Christchurch Northern Corridor | Community Safety: Reduced Speed Zones

Christchurch Northern Corridor | Community Safety: Intersection Upgrades

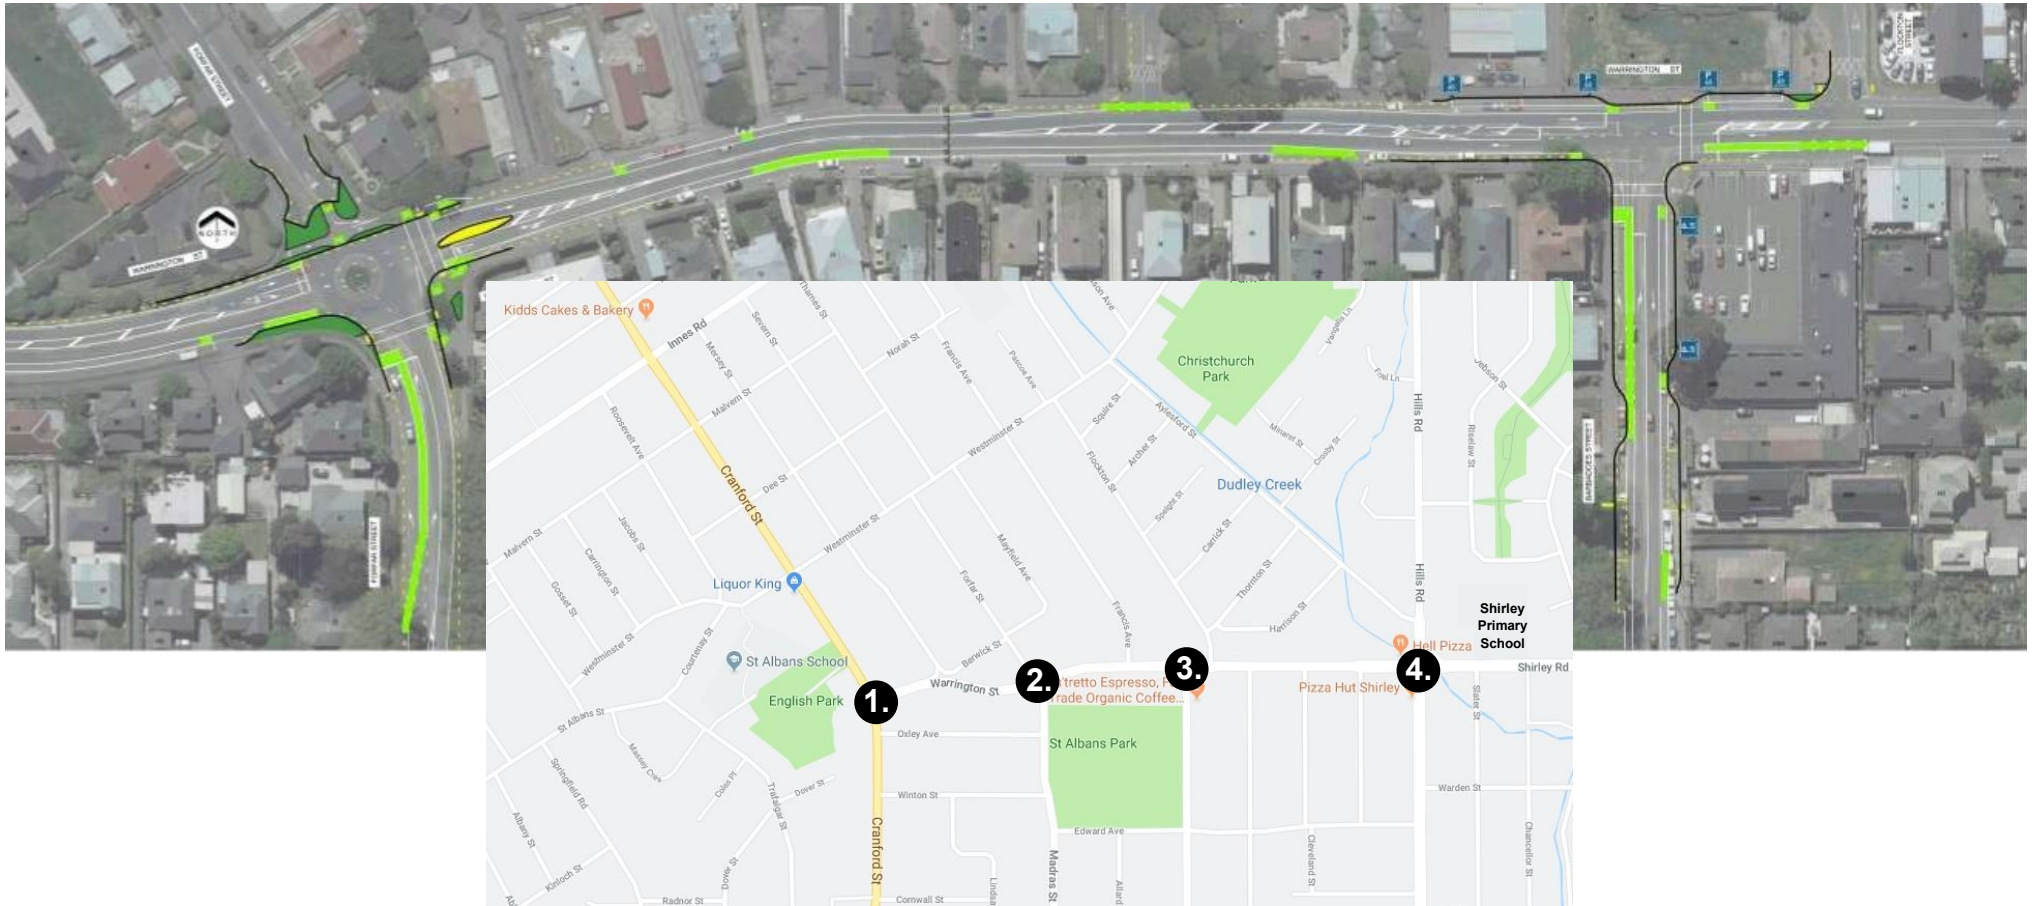
1. Cranford Street and Westminster Street: Agree, currently it is very hard to turn right here, cars waiting to turn block the traffic flow on Cranford Street.

2. Warrington Street and Forfar Street: Disagree, I use this roundabout a lot, it is safe and it works well with the traffic flow.
This is also the safest place to turn right (between Hills Road & Cranford Street) onto Forfar Street, to get onto Westminster Street and/or Innes Road, if you are coming from Shirley Road. Closing Forfar Street will push traffic onto smaller residential streets, causing more problems for this area.

3. Warrington Street and Barbadoes Street: Agree, this intersection needs to be safer, very congested area with cars stopping at the shops and busy side streets with cars turning onto Warrington Street.

4. Hills Road and Shirley Road: This intersection is extremely busy. Four sets of lights on Westminster Street from Hills Road to Cranford Street is too many, very overwhelming and frustrating for drivers.

Christchurch Northern Corridor | Community Safety: St Albans School

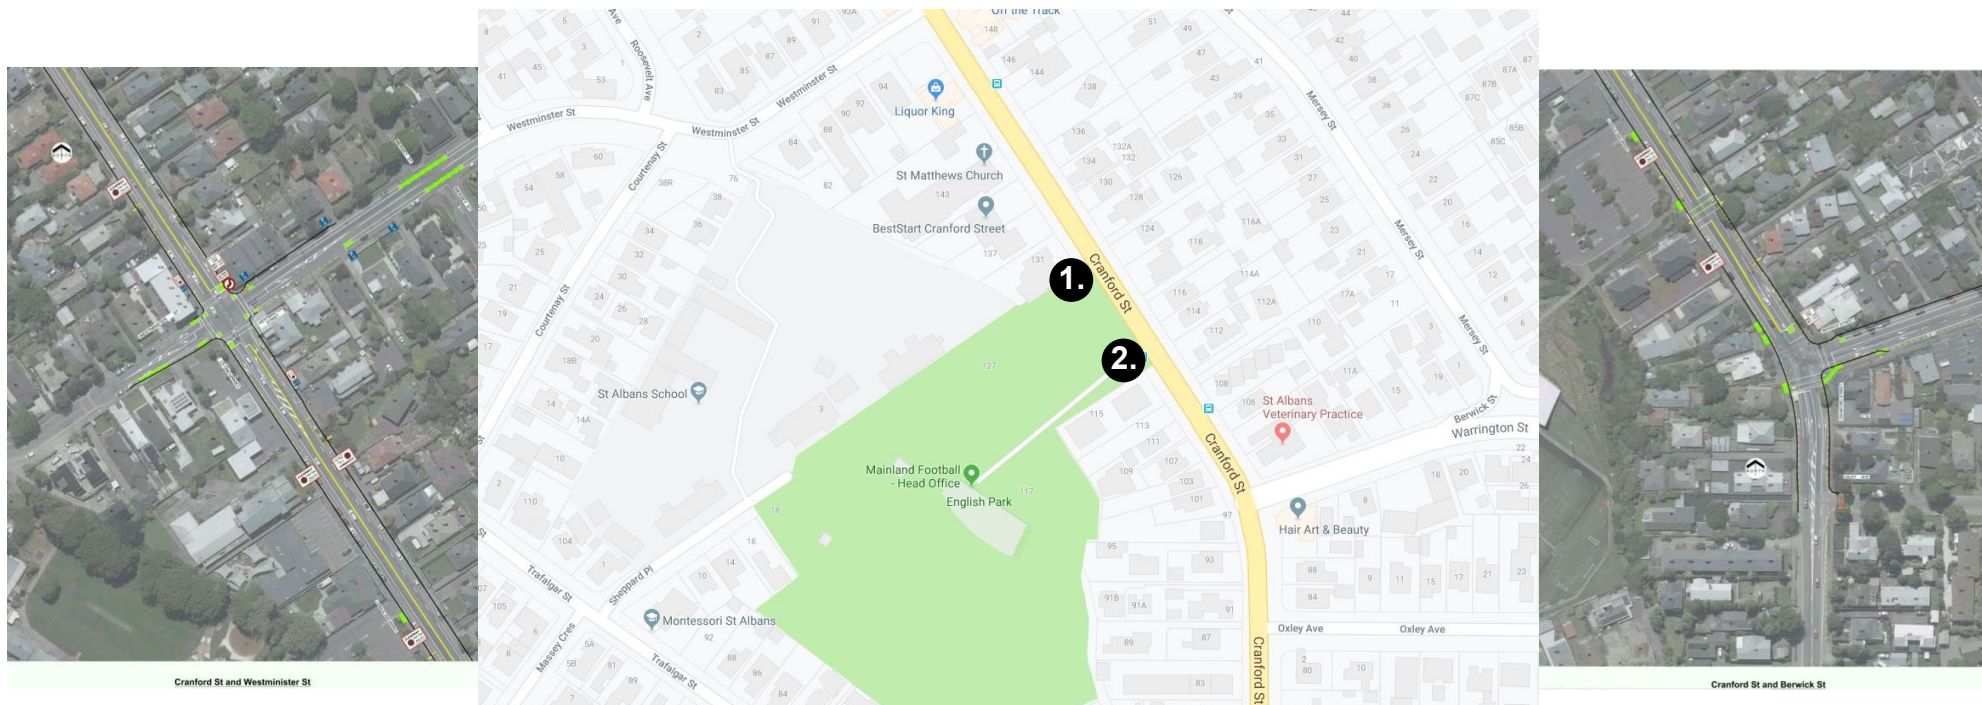
New Pedestrian Signal Crossing outside English Park: Agree, this is a very busy & distracting area during St Albans School drop off/pick up times.

- Pedestrian crossing needs to be at 1. to connect with the path from St Albans School.
- English Park carpark needs to have an entrance at 2. and an exit at 1., so this carpark can be used during school drop offs/pick ups.

- Westminister Street and Courtenay St next to St Albans School need to be “No Parking” during school drop offs/pick ups to make it safer.
- Cranford Street from Westminister Street to Warrington Street needs to be “40kmph School Zone” during school drop offs/pick ups to make it safer.

- Could all St Albans School students/parents be asked to use this new pedestrian signal crossing, instead of the existing traffic signals?
- Cranford/Warrington lights: pedestrians crossing delay drivers turning onto Cranford, traffic backs up on Warrington.

- Cranford/Westminister lights: bottleneck with cars turning onto Cranford and cars coming/going from St Albans School.
- Due to our experience with red light runners at the pedestrian signal crossing outside Shirley Primary School, I would suggest the same 3 second delay from the red lights for the drivers, before activating the green pedestrian crossing light.

- St Albans School students need to be aware that drivers could be looking at the next set of lights and become distracted/overwhelmed by their surroundings, with 3 set of lights so close together. Students will need to be taught & reminded by the adults at the pedestrian signal crossing to wait until the cars have stopped before crossing.

Christchurch Northern Corridor | Community Safety: Traffic Calming Options

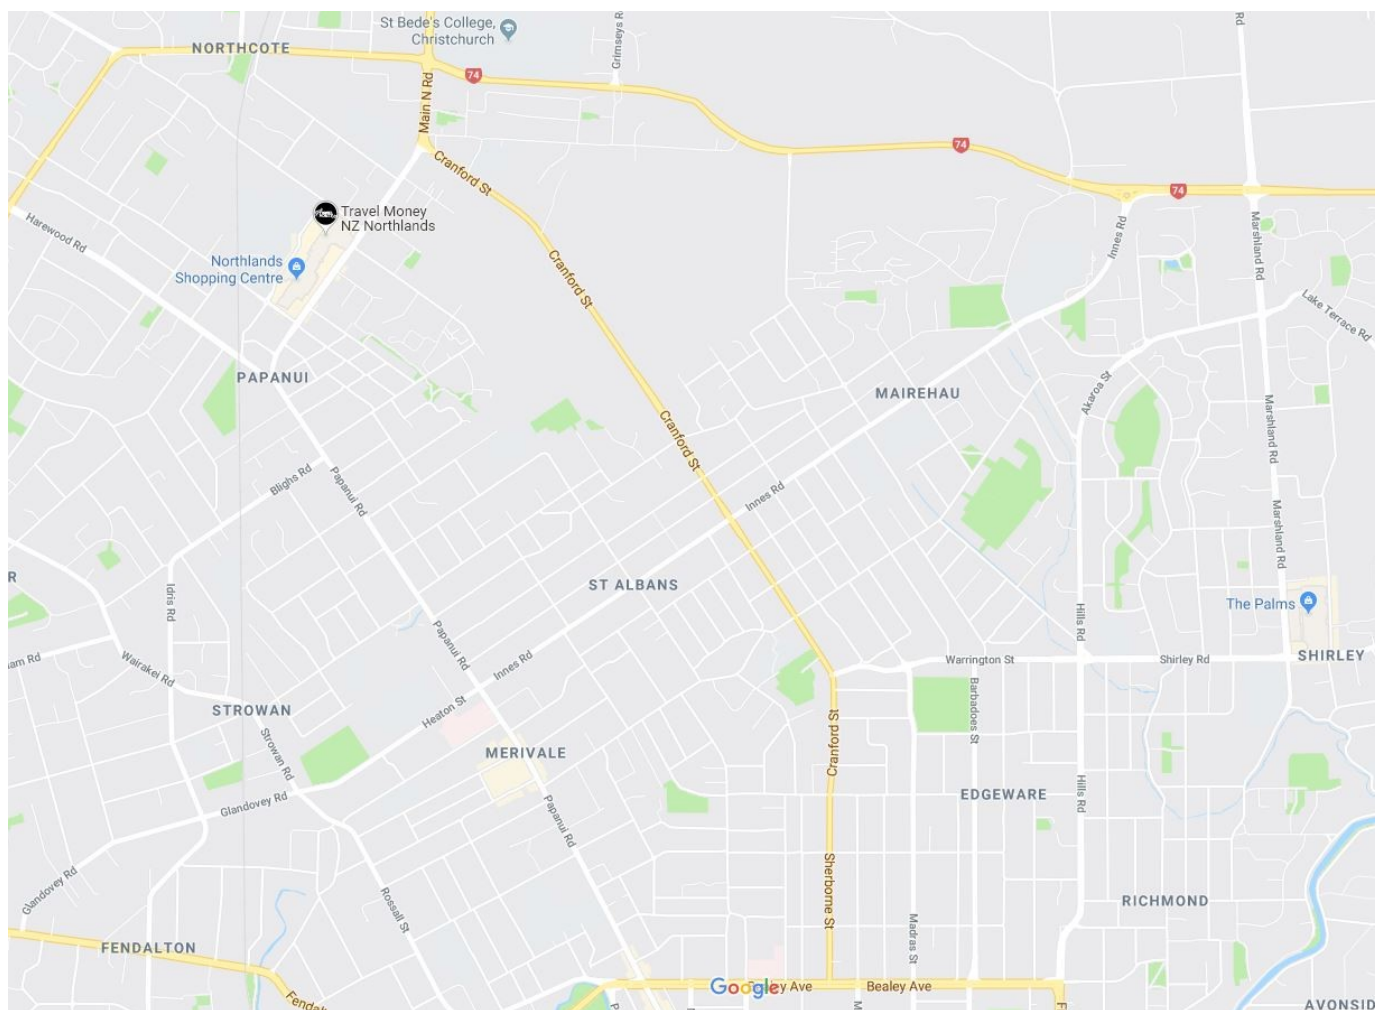
Traffic calming decisions should be deferred at this stage, until there is a known problem with a particular street. By lowering the speed limit to 40km/h, drivers using the CNC motorway will consider the alternate routes in/out of the CBD:

1. Harewood Road/Papanui Road, 2. Philpotts Road, 3. Hills Road, 4. Marshland Road
